2.2 Control and Instrument Systems

The information in this section of the reference ABWR DCD, including all subsections, tables, and figures, is incorporated by reference with the following departures.

Figure 2.2.1 Rod Control and Information System Control Interface Diagram

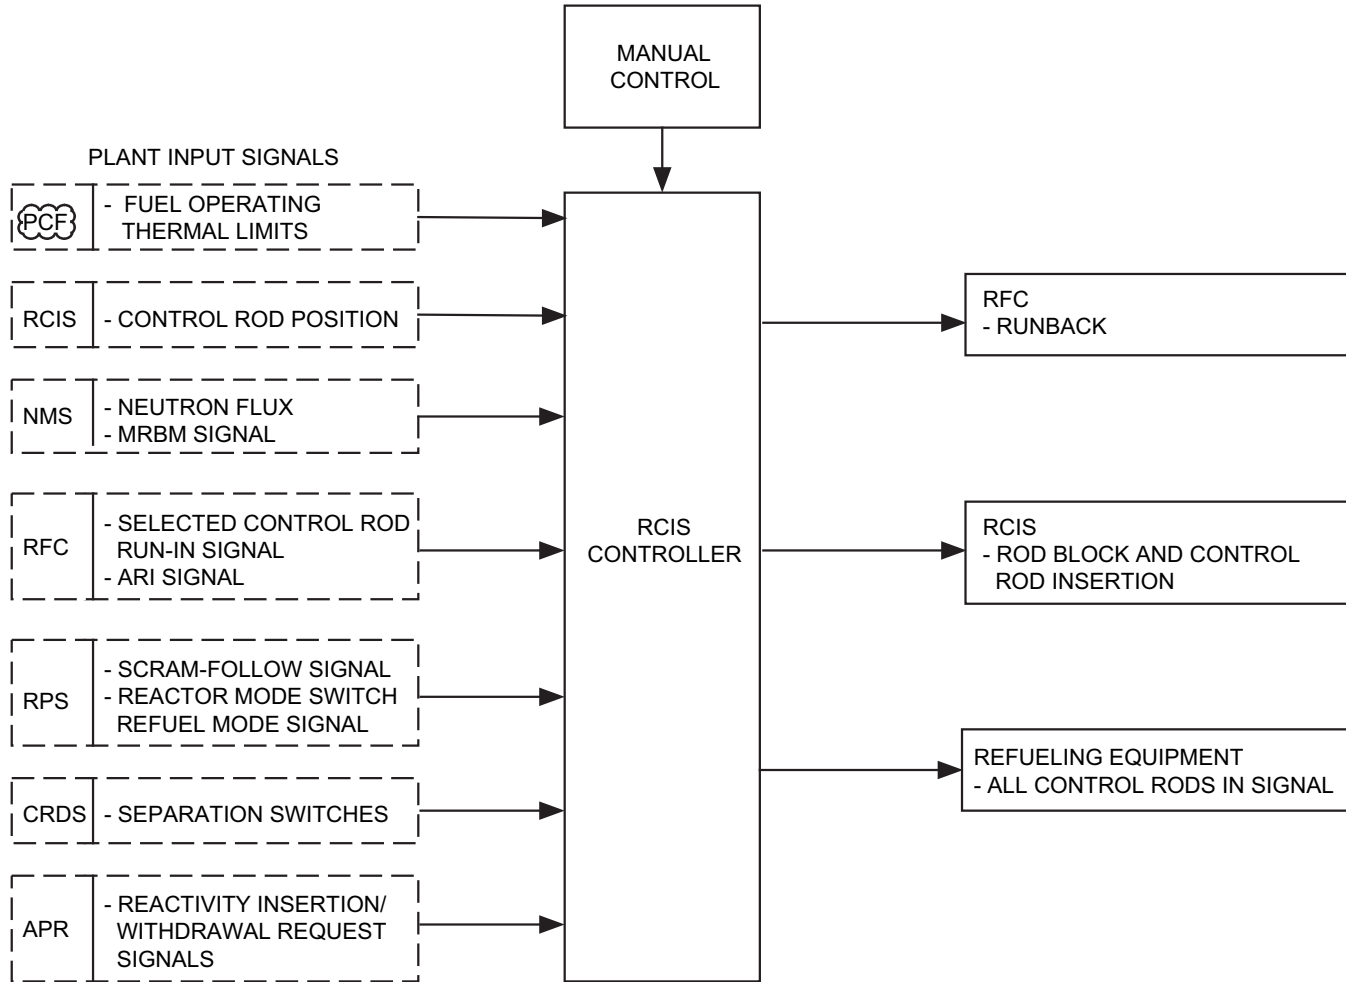
STD DEP T1 3.4-1 (Figure 2.2.1)

NOTE:
1. INTERCONNECTIONS MAY BE FIBER-OPTIC OR METALLIC.

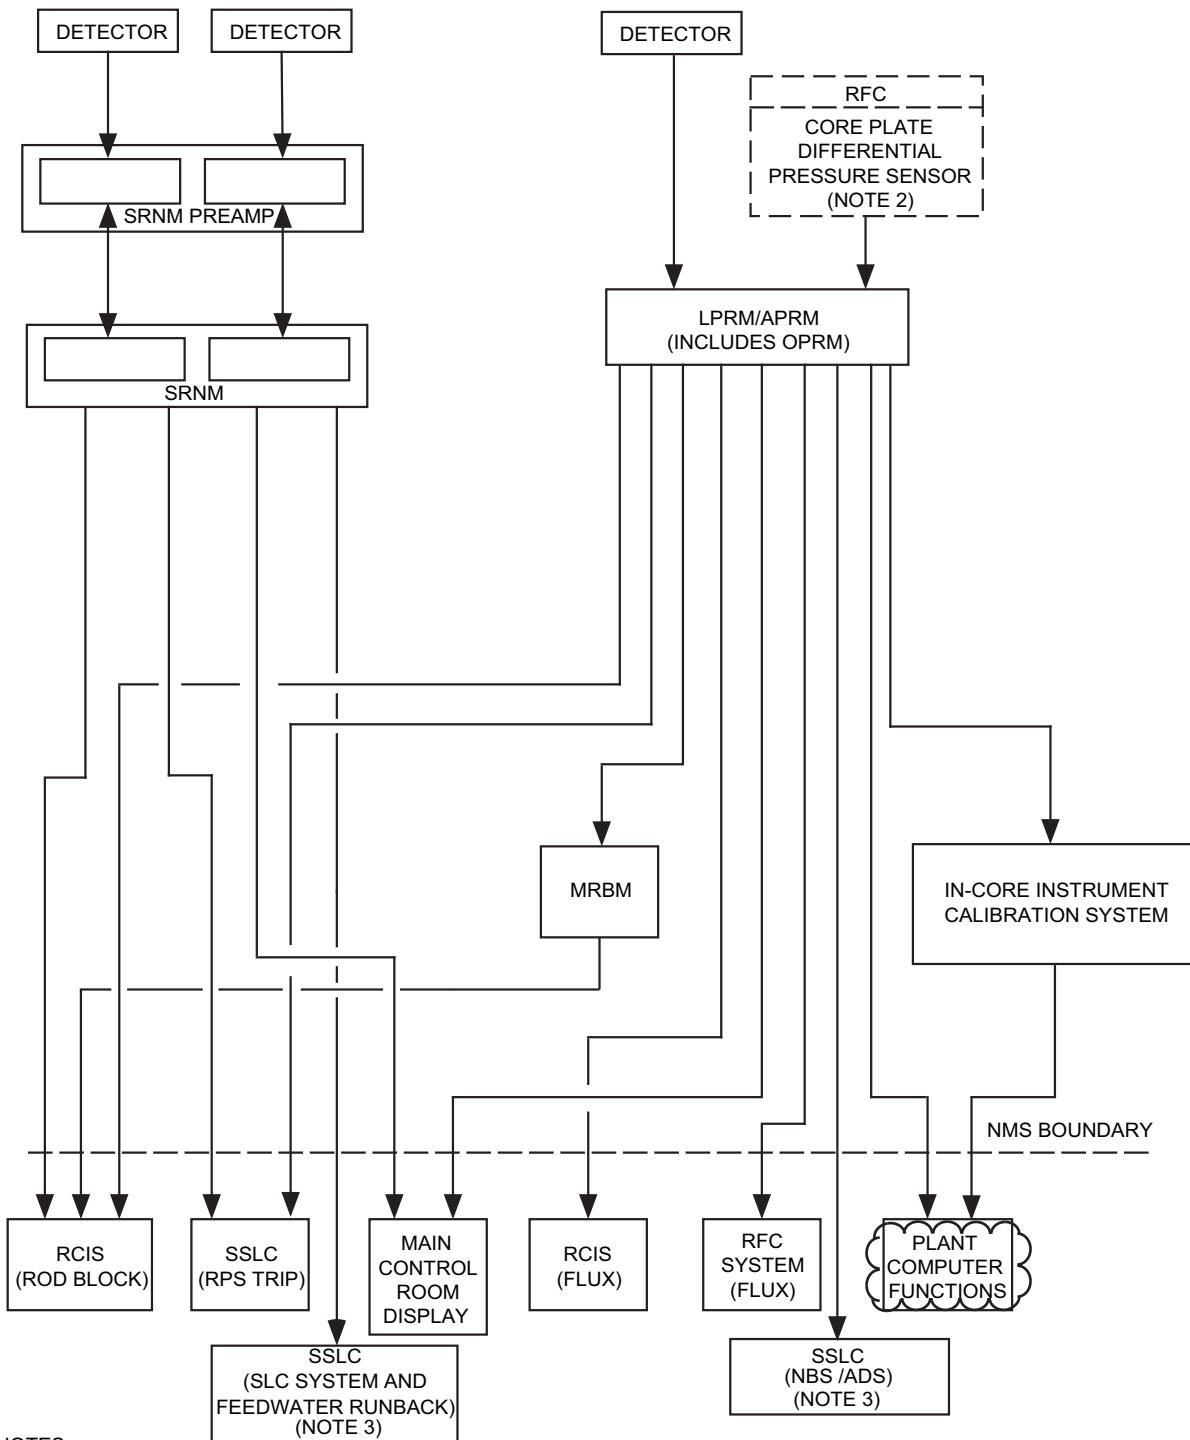
The FDWC digital controllers determine narrow range level signal using three reactor level measurement inputs from the NBS. ~~Sensor signals are transmitted to the FDWC digital controllers by the Non-Essential Multiplexing System (NEMS).~~

The steam flow in each of four main steamlines is sensed at the RPV nozzle venturis. ~~Sensor signals are transmitted to the FDWC System digital controllers by the NEMS.~~ These measurements are processed in the digital controllers to calculate the total steam flow out of the vessel.

Feedwater flow is sensed at a flow element in each of the two feedwater lines. ~~Sensor signals are transmitted to the FDWC digital controllers by the NEMS.~~ These measurements are processed in the digital controllers to calculate the total feedwater flow into the vessel.

Figure 2.2.5 Neutron Monitoring System

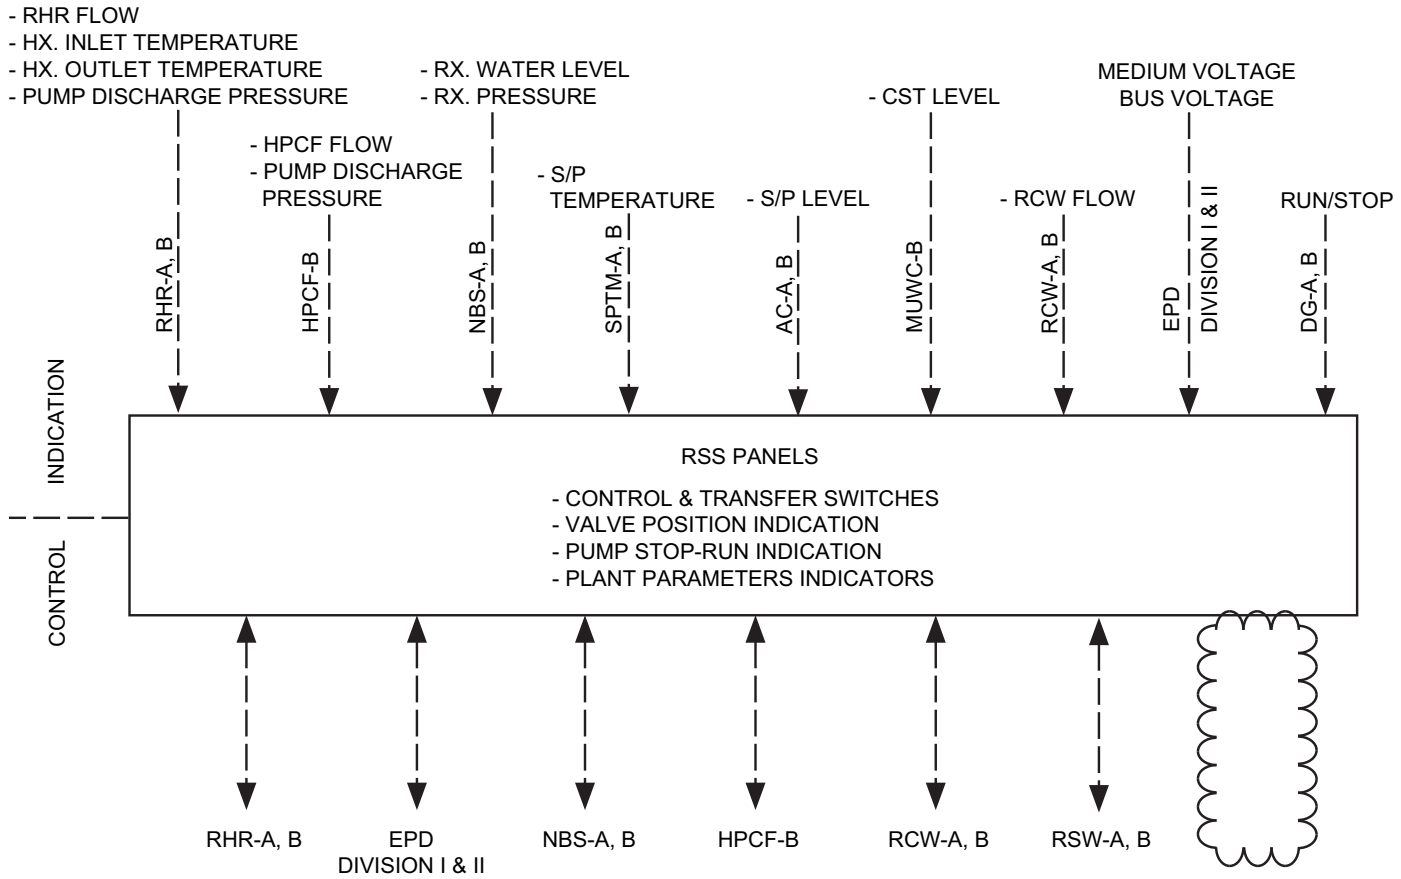
STD DEP T1 3.4-1 (Figure 2.2.5)

The automated in-core instrument calibration system provides local power information at various core locations that correspond to LPRM locations. The automated in-core instrument calibration system uses its own set of in-core detectors for local power measurement and provides local power information for three-dimension core power determination and for the calibration of the LPRMs. The measured data are sent to the ~~Process Computer System~~ Plant Computer Functions for such calculation and LPRM calibration.

Figure 2.2.7b Reactor Protection System

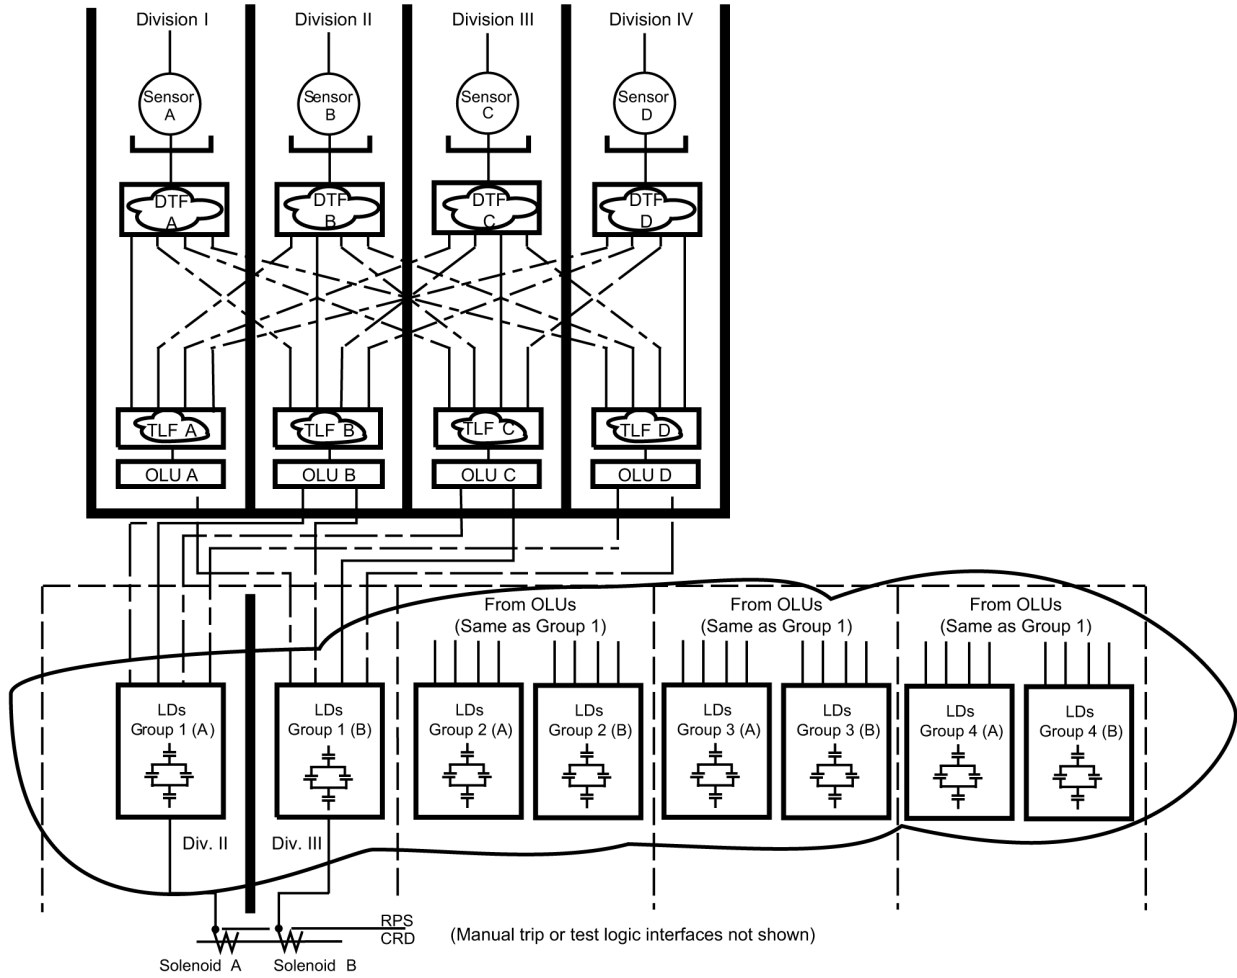
STD DEP T1 3.4-1 (Figure 2.2.7b)

The RPS has four divisions. Figure ~~2.2.6a~~ 2.2.7b shows the RPS divisional aspects and the signal flow paths from sensors to scram pilot valve solenoids. Functions Equipment within an RPS division consists of include sensors (transducers or switches), I/O, ~~multiplexers~~, data communication, digital trip ~~modules~~ functions (DTM DTF), trip logic ~~unit function~~ (TLU TLF), output logic unit (OLU), and load drivers (LD). The LDs are only in Divisions II and III. The (DTF) and (TLF) are performed in digital configurable logic devices. The data communication functions are described in Section 2.7.5.

The RPS consists of logic and circuitry for initiation of both automatic and manual scrams. The automatic scram function is ~~comprised of~~ accomplished redundantly in four independent divisions of sensor instrument channels, hardware/software based logic and logic processing, and two independent divisions of actuating devices. Automatic scram is initiated whenever a scram condition is detected by two or more automatic divisions of RPS logic. ~~For automatic scram, the sensor input signals to the RPS originate either from the RPS's own sensors or other systems' sensors. For determination of the existence of an automatic scram condition, within each automatic scram channel division of the RPS, the DTM DTF of a given RPS channel division compares the monitored process variable with the a stored setpoint stored in its memory and issues a trip signal if the monitored process variable exceeds the setpoint. The DTM DTF then sends the trip signal to the TLU TLF of its own channel division and the TLU TLFs of the other three channels divisions of RPS, where two-out-of-four voting is performed (see Figure 2.2.6a). The TLF in each division performs an independent two-out-of-four vote on each RPS DTF input.~~
